# Work Order ID 101945

Item Name: Crosstube Turning Detail

DRAWING NO. D412-664-243		TITLE CROSSTUBE ASS'Y (412 HI AFT)		REV. E		DART AEROSPACE LTD ENGINEERING ORDER		D.E.O. NO. D412-664-243-E-2		SHEET NO. SHEET 1 OF 1		SCALE NTS	
DRAWN <i>MP</i>		CHECKED <i>ASS</i>		MFG. APPR. <i>E</i>		APPROVED <i>MP</i>		DE APPR. <i>H</i>					
DATE 11.09.07		DATE 11.09.19		DATE 11.09.19		DATE 11.09.19		DATE 11.09.19

DRAWING NO. D412-664-243	TITLE CROSSTUBE ASSEMBLY (412 HI AFT)	REV. E	DART AEROSPACE LTD ENGINEERING ORDER		D.E.O. NO. D412-664-243-E-4	SHEET NO. SHEET 1 OF 3	SCALE NTS
DRAWN 97	CHECKED A	MFG. APPR. A	APPROVED MP		DE APPR. MP		
DATE 12.08.21	DATE 12.08.30	DATE 12.08.30	DATE 12/8/30		DATE 12.08-30

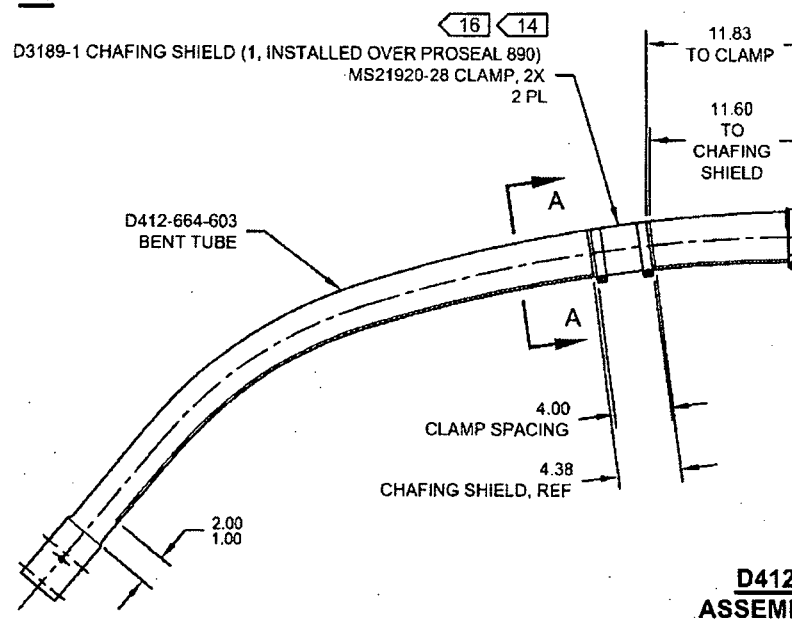
REMOVED ABRASION STRIP IN FAVOR OF A THIN LAYER OF PROSEAL 890. UPDATE INSTALLATION OF CHAFING SHIELDS AND REDUCE TORQUE TO 40-50 IN-LBS. THIS ENGINEERING ORDER SUPERCEDES DEO D412-664-243-E-1.

**NOTES 2, 14, AND 16 ON SHEET 1 ARE AMENDED AS FOLLOWS:**

- 2) FINISH: CHEMICAL CONVERSION COAT PER DART QSI 005 4.1  
PRIME INSIDE AND OUTSIDE PER DART QSI 005 4.2  
MASK UNDERSIDE OF CROSSTUBE AS SHOWN (HATCHED AREA)  
PAINT OUTSIDE PER DART QSI 005 4.2  
AFTER PAINTING, APPLY CLEAR COAT ON HATCHED AREA
- 14) APPLY A THIN COAT OF PROSEAL 890 ON INSIDE CONCAVE SURFACE OF D3189-1 CHAFING SHIELD AND LET CURE PER MANUFACTURER'S INSTRUCTIONS. INSTALL PROSEALED D3189-1 CHAFING SHIELD ONTO CROSSTUBE BY APPLYING A THIN COAT OF PROSEAL 890 ONTO CROSSTUBE. BE SURE TO ELIMINATE ANY AIR GAPS.
- 16) TORQUE CLAMPS ON D2896-1 SUPPORT 80 TO 100 IN-LB. **TORQUE CLAMPS ON D3189-1 CHAFING SHIELD 40 TO 50 IN-LB.** ENSURE AT LEAST 1.5 THREADS SHOWING IN SAFETY AND THAT NUT HAS NOT BOTTOMED-OUT AFTER TORQUING.

- 2) FINISH: CHEMICAL CONVERSION COAT PER DART QSI 005 4.1  
PRIME INSIDE AND OUTSIDE PER DART QSI 005 4.2  
PAINT OUTSIDE PER DART QSI 005 4.2
- 14) INSTALL D2856-600-1009 ABRASION STRIPS WITH A 0.13 REF GAP ON BOTTOM SIDE OF CROSSTUBE PER QSI 035.
- 16) TORQUE CLAMPS 80 TO 100 IN-LB. ENSURE AT LEAST 1.5 THREADS SHOWING IN SAFETY AND THAT NUT HAS NOT BOTTOMED-OUT AFTER TORQUING.

**D412-664-243  
ASSEMBLY DETAIL**

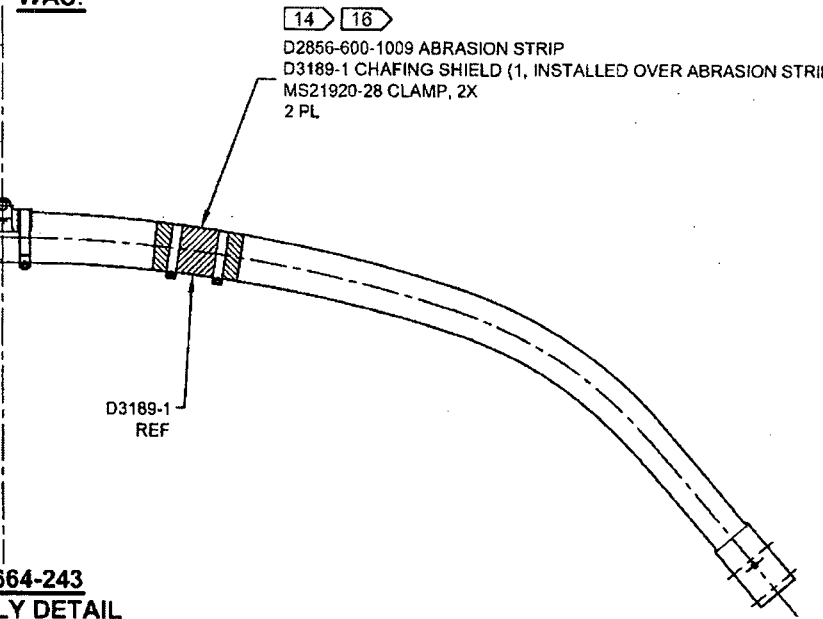
D3189-1 CHAFING SHIELD (1, INSTALLED OVER PROSEAL 890)  
MS21920-28 CLAMP, 2X  
2 PL

D2856-600-1009 ABRASION STRIP  
D3189-1 CHAFING SHIELD (1, INSTALLED OVER ABRASION STRIP)  
MS21920-28 CLAMP, 2X  
2 PL

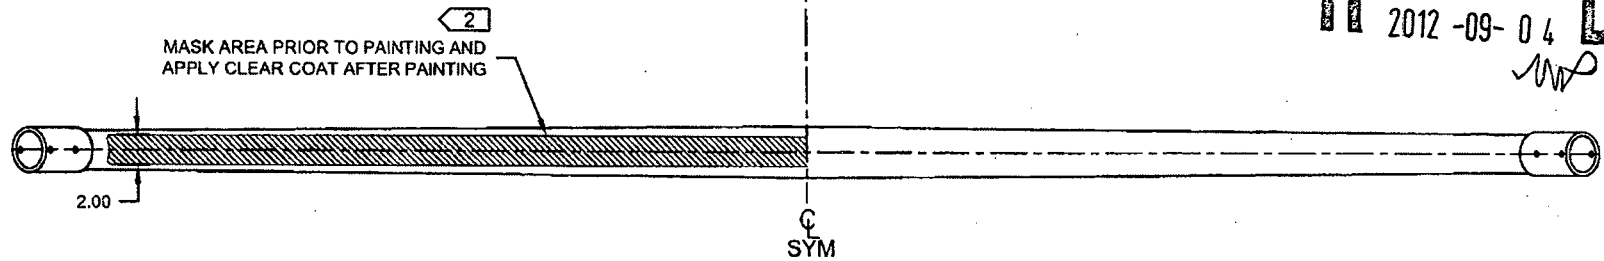
MASK AREA PRIOR TO PAINTING AND  
APPLY CLEAR COAT AFTER PAINTING
